## Technical Release Note R04-22 Configuration Software 4.0.0

<b>Date</b>	January 10, 2021
<b>Product Line</b>	Configuration Software
<b>Software Ver.</b>	4.0.0

RISCO Group has released a new version of the Configuration Software (CS) with support of LightSYS Plus and some improvements.

*Image 1: SIA IP Channel Information*

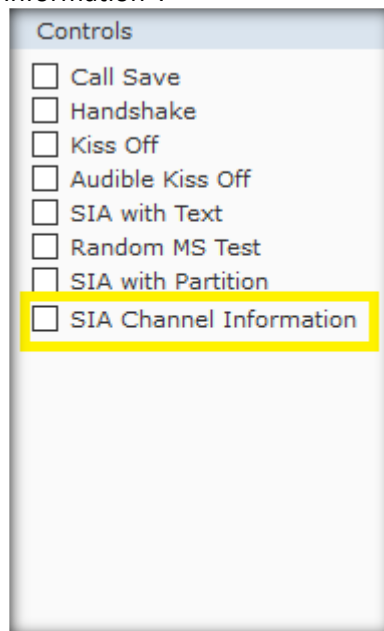
1. MS Screen – adding new flag: SIA IP Channel Information – If enabled, the SIA IP string will be sent to MS with the channel source (IP/GSM).

**Note:** On this CS version it appears “SIA Channel Information” will be fixed on the next version to “SIA IP Channel Information”.

Image 2: RX Report

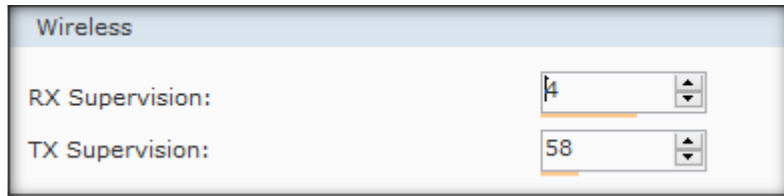
5. Remove the Siren Mode LS/Bell from the status screen.
6. Encryption enable/disable parameter for Cloud communication (Cloud screen). By default this flag is enabled.
7. Remove 'Payment Expired' from the status screen.
8. Remove 'On Board Tamper' from the status screen. (This tamper is not relevant anymore).
9. Remove 'Confirmed Alarm' from MS Screen → Report Code → Zones tab.
10. Relocate the 'TX Supervisor' from the Timers table to the Wireless table (Remain on the same screen of Timers)
